April 17, 2024

Amendment to Revised Remedial Action Options Report (RAOR)

Former Town of Newton Gravel Pit
3130 Hecker Road, Manitowoc, Wisconsin
BRRTS No. 02-36-000268

FIGURE 2 EXTRACTION WELL LOCATIONS

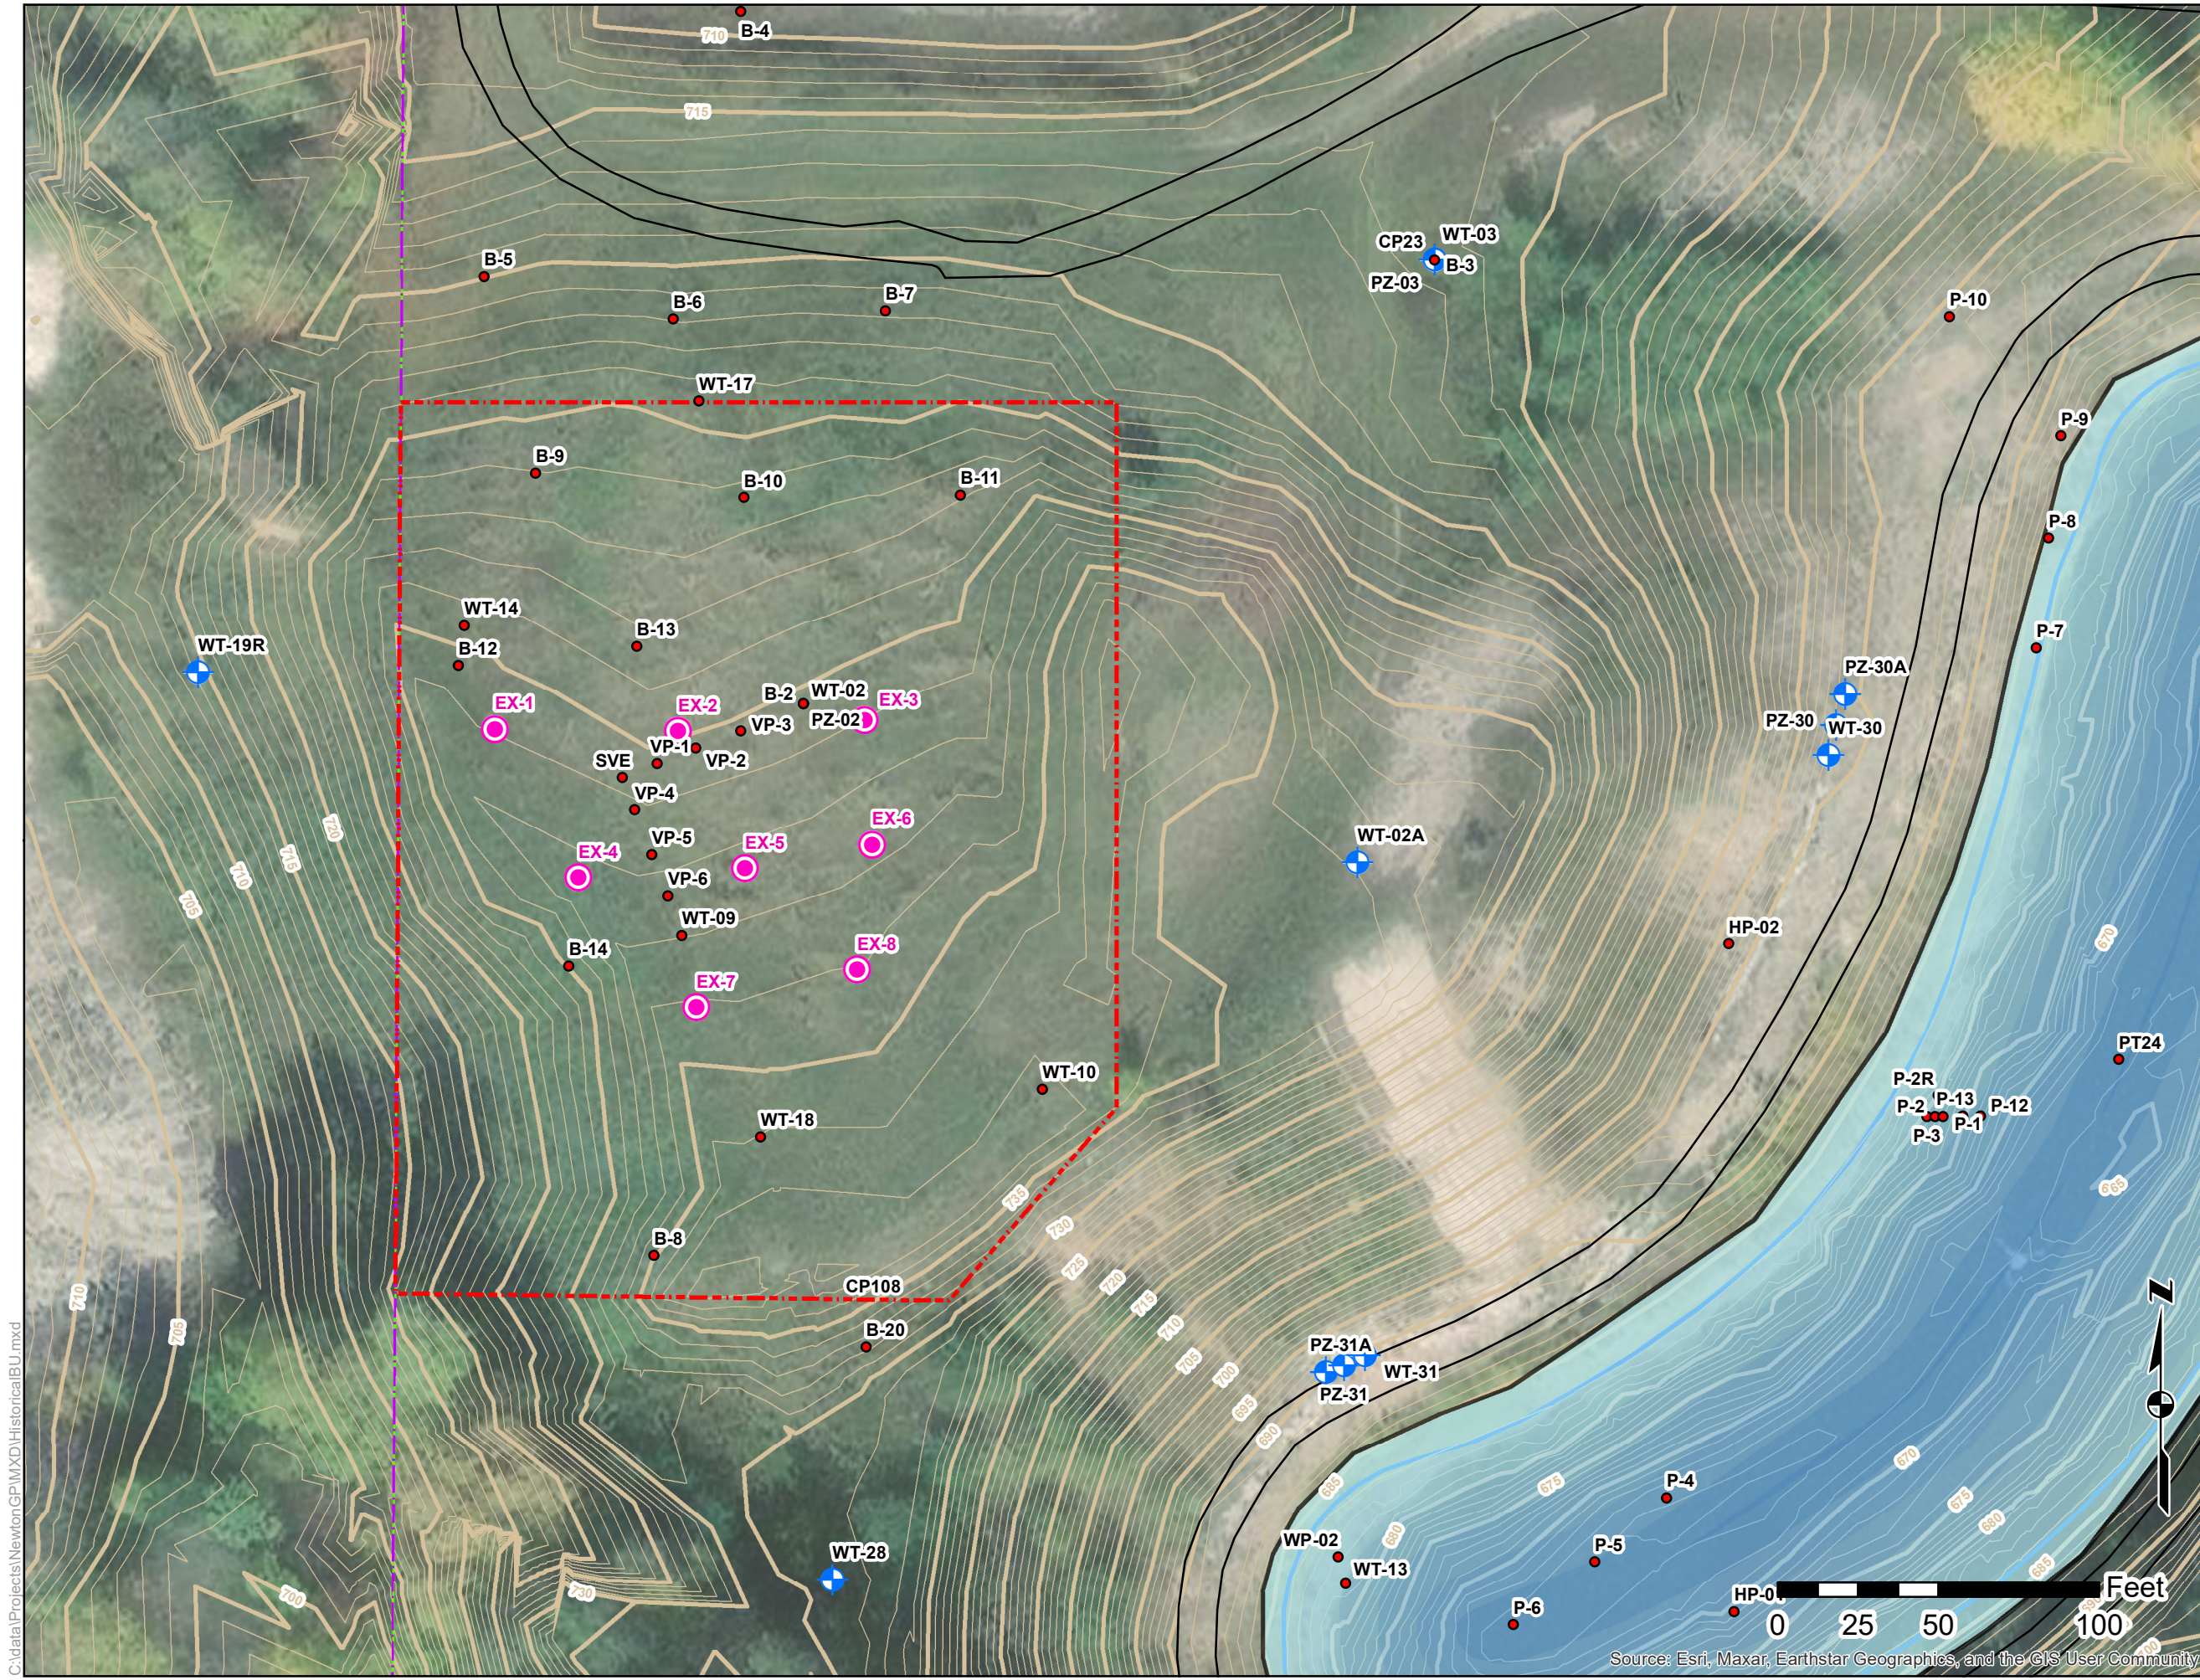
Based on nine-months of monitoring without measurable levels of LNAPL along with VOC groundwater results confirming the core of the Western Source Area, AECOM proposes an amendment to the Revised RAOR that would include installation of the infrastructure for an LNAPL system but, at this time, would not include installation of the treatment equipment associated with the system. Specifically, AECOM proposes the following changes to the LNAPL system design:

- Originally proposed design, eight SVE wells, of which six wells would also be used for LNAPL recovery.
- Amended design, eight SVE wells, of which five wells (EX-1, EX-2, EX-3, EX-4, and EX-5) would also be used for LNAPL recovery.

- Originally proposed design, wellhead and trenched in carrier pipe for six wells along with treatment building equipment space.
- Amended design, wellhead and trenched in carrier pipe for five wells (EX-1, EX-2, EX-3, EX-4, and EX-5). The equipment building will be sized to accommodate the possible addition of LNAPL treatment equipment at a later date.

- Originally proposed design, purchase and install all LNAPL treatment equipment.
- Amended design, purchase and installation of LNAPL treatment equipment is postponed to a later date and only if site conditions dictate the need for the equipment.

SVE enhanced LNAPL recovery is a known technology to improve LNAPL recovery from extraction wells. Therefore, it is possible that once the SVE system is operational, there will be an influx of LNAPL into the extraction wells. Under the amended RAOR, AECOM proposes to monitor for LNAPL in the extraction wells and respond in a two-step manner if LNAPL is detected:

1. Begin LNAPL recovery using 3-inch dia. absorbent socks.
2. If, after a period of time, the absorbent socks cannot keep up with the recovery of LNAPL, AECOM will revisit purchasing and installing LNAPL recovery equipment in one or more wells, as needed.
